**Town of Kittery  
Planning Board Meeting  
September 14, 2023**

**ITEM 1 – Green Truck Farm/ 89 Route 236 Site Plan Modification (Final) and New Marijuana Business Review**

Proposal: change use of portion of existing commercial building to adult-use marijuana business and extend sewer main to serve the subject property.

Property: 89 Route 236; Tax Map 28, Lot 14-2

DRAWING No.  
**C2**  
 SHEET 3 OF 9  
 JBE PROJECT NO. 21076

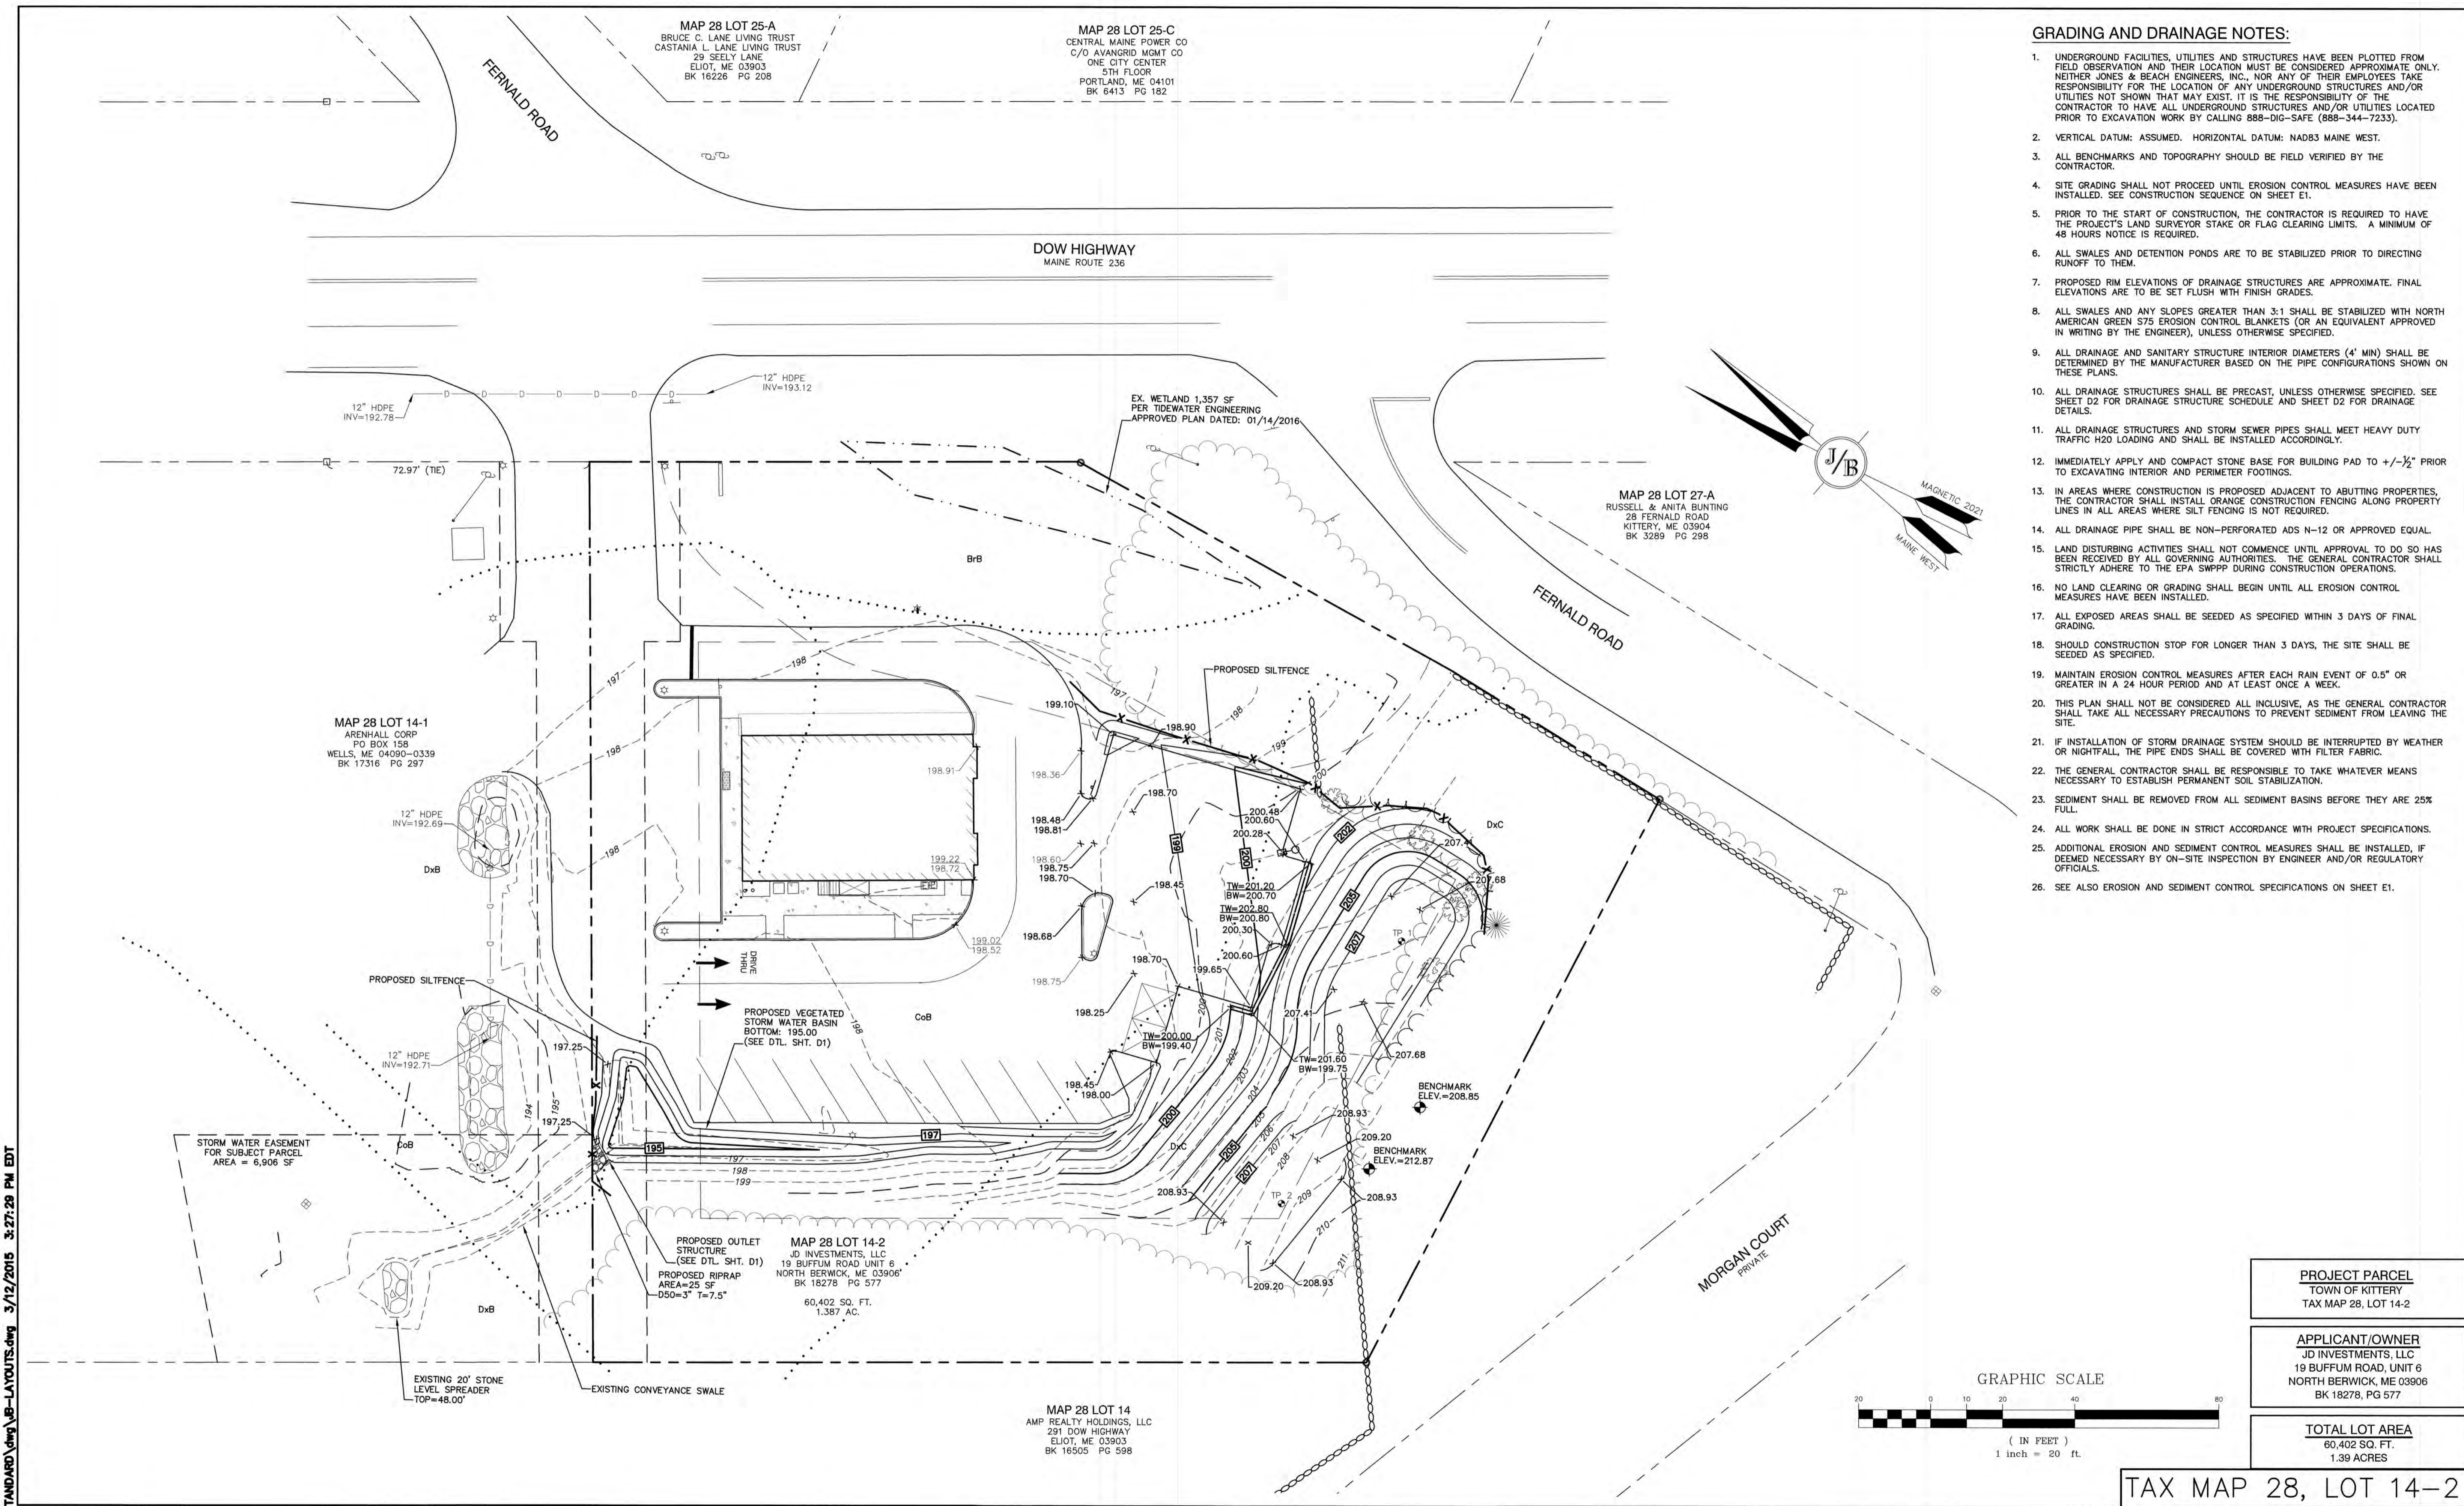
6. *Provide a snow removal note on the plans for excess snow to be trucked off site.*  
**RESPONSE:** Note 21 on Sheet C2 has been added stating this requirement.

- **The power for the proposed light pole will be pulled from the existing light pole adjacent to the dumpster pad. The conduit is depicted on the Site Plan (Sheet C2).**
- **The test pits, which were dug in preparation for the replacement septic system, have been added to the plans (Sheets C1 & C4).**
- **A proposed cross walk has been added to provide safe pedestrian access to the proposed parking field. This cross walk is depicted on the plans.**

DRAWING No.  
**C3**  
SHEET 4 OF 9  
JBE PROJECT NO. 21076

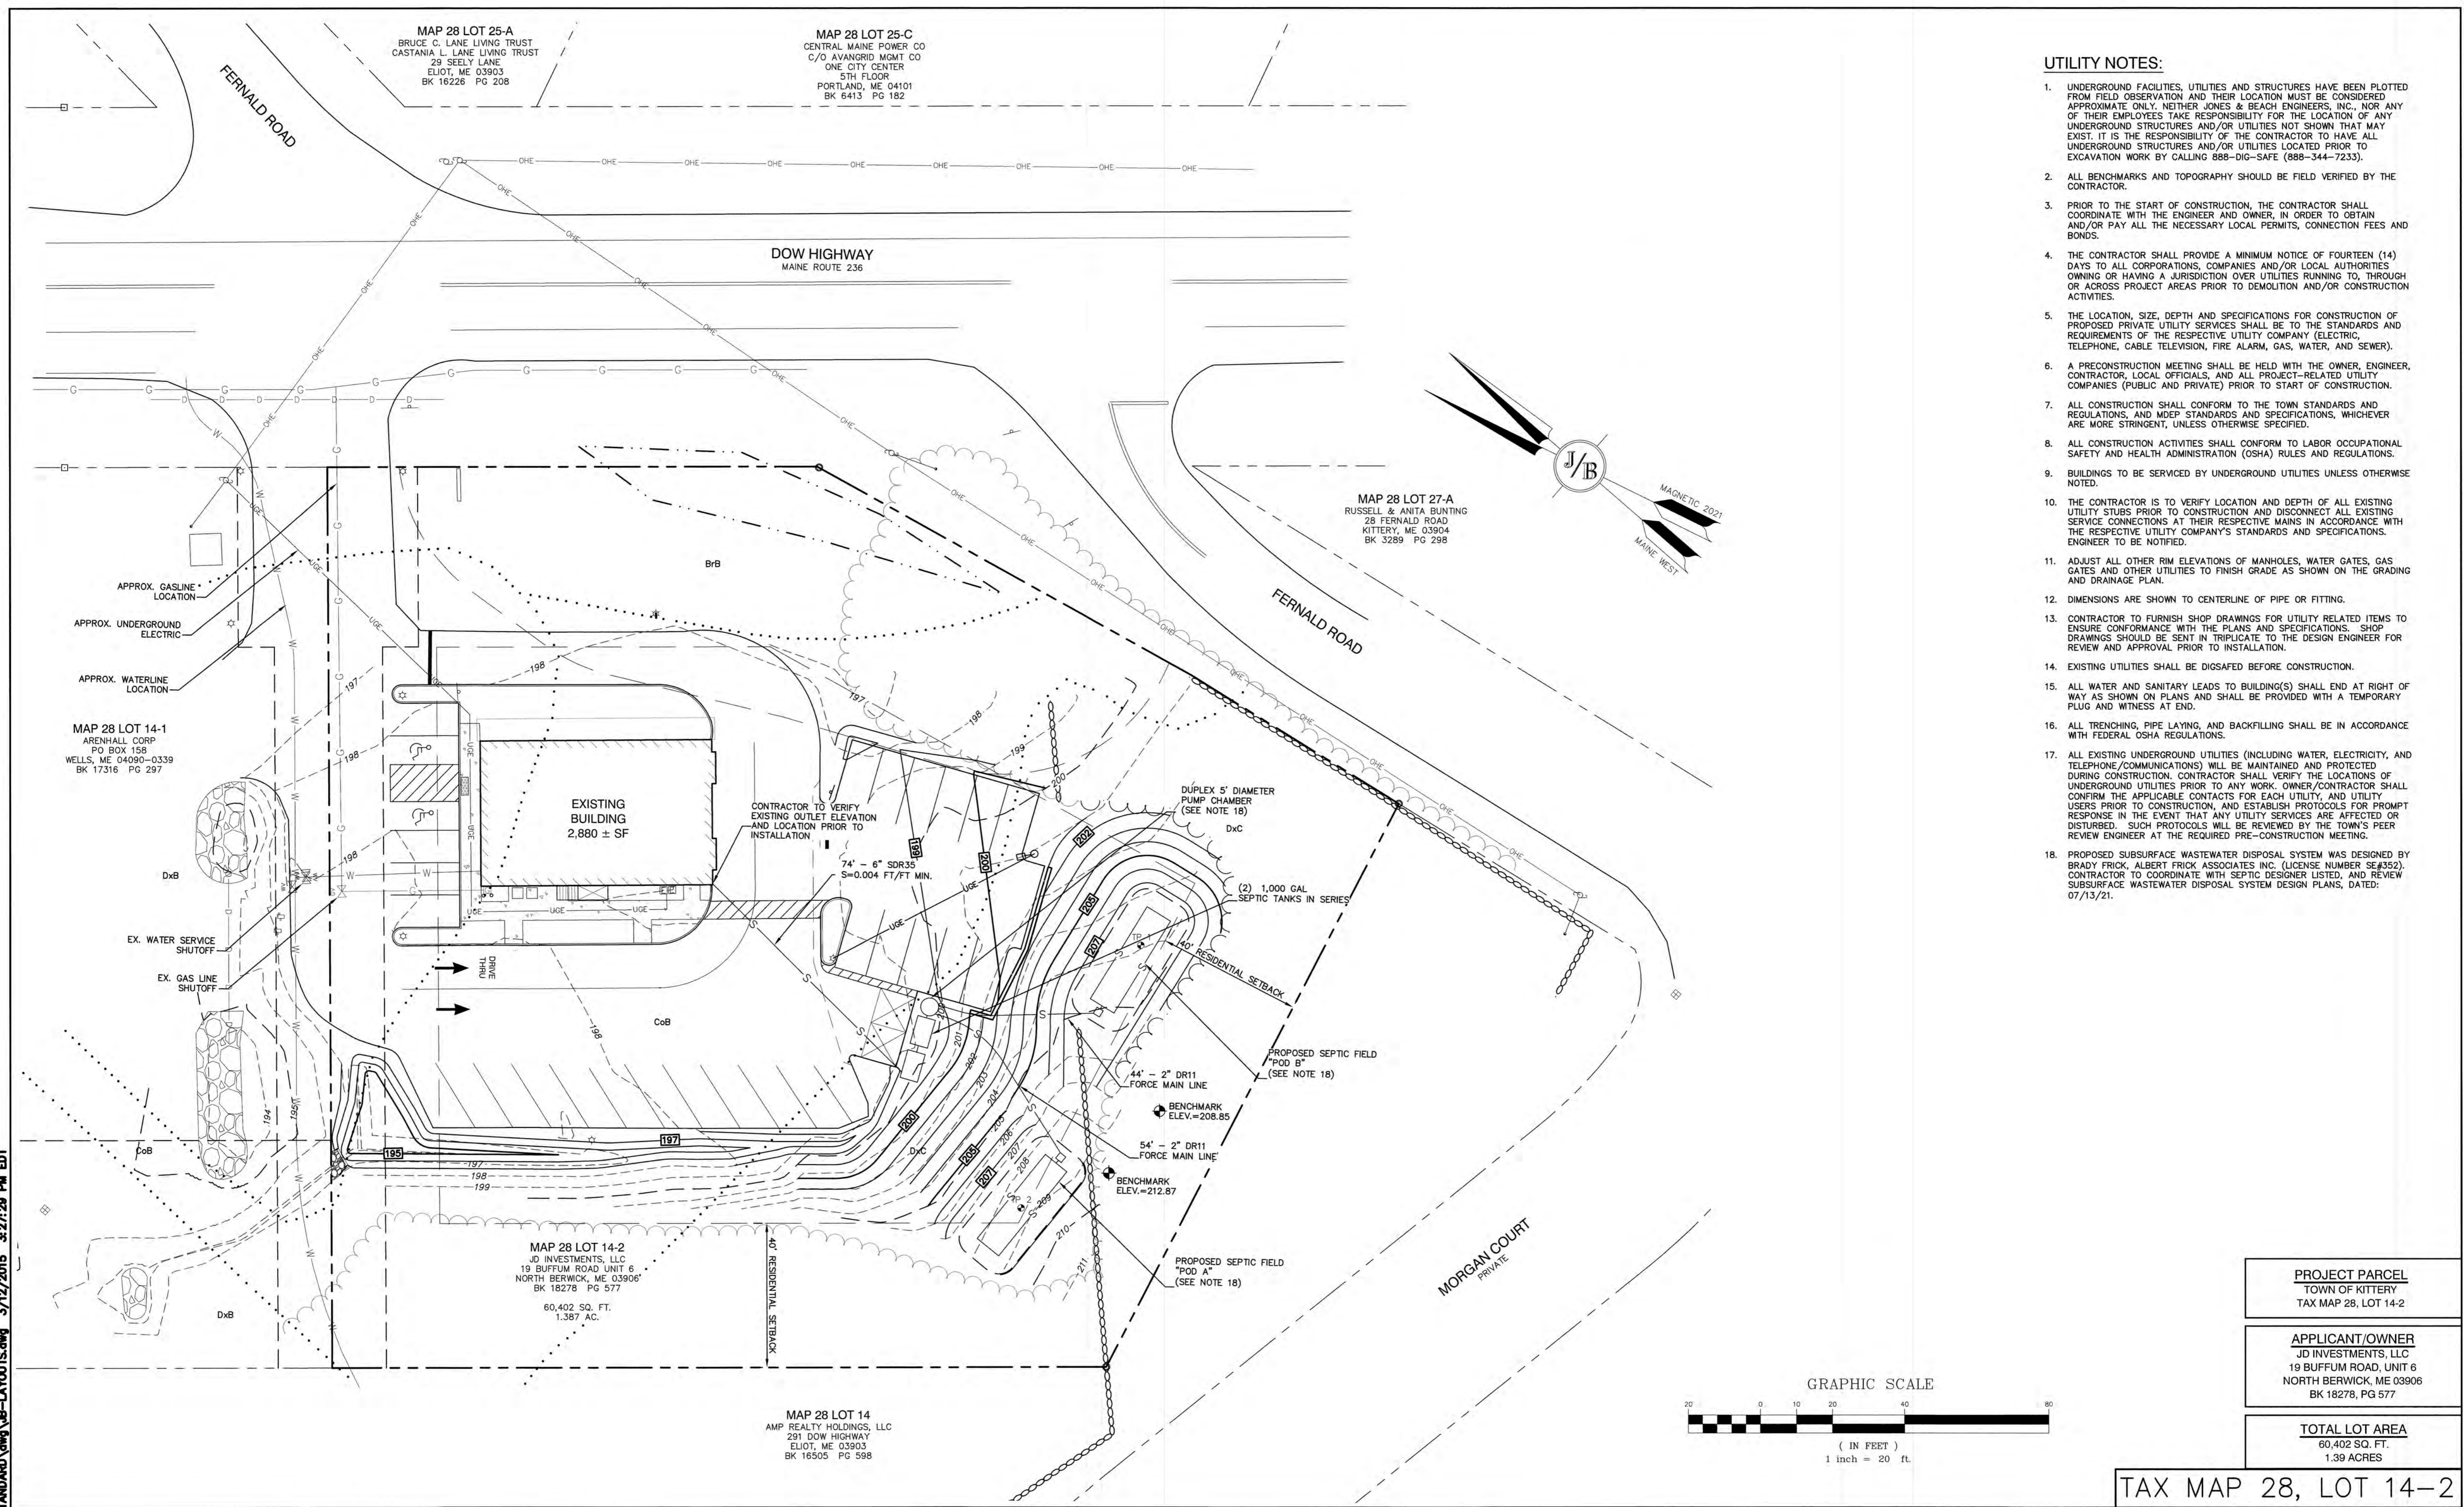
2. *The applicant should provide details for the stormwater basin and outlet structure. Leaders on Sheet C3 reference detail Sheet D1, but this was not included in the plan set.*

The applicant should provide details for the stormwater basin and outlet structure. Leaders on Sheet C3 reference detail sheet D1, but this was not included in the plan set.

**RESPONSE: The details in question are included on Sheet D1. This Sheet has been included in the updated plan set included with this letter.**
3. *Following the site walk the Town of Kittery requested additional information with respect to the classification of existing pond on site. Gove Environmental Services, Inc. provided a response letter and characterization of the stormwater feature as a detention pond and not a wetland. Their assessment includes discussion of a DEP Stormwater/Site Law permit for maintenance requirements. Does the applicant have this permit? A copy should be submitted to the Town for the project record.*
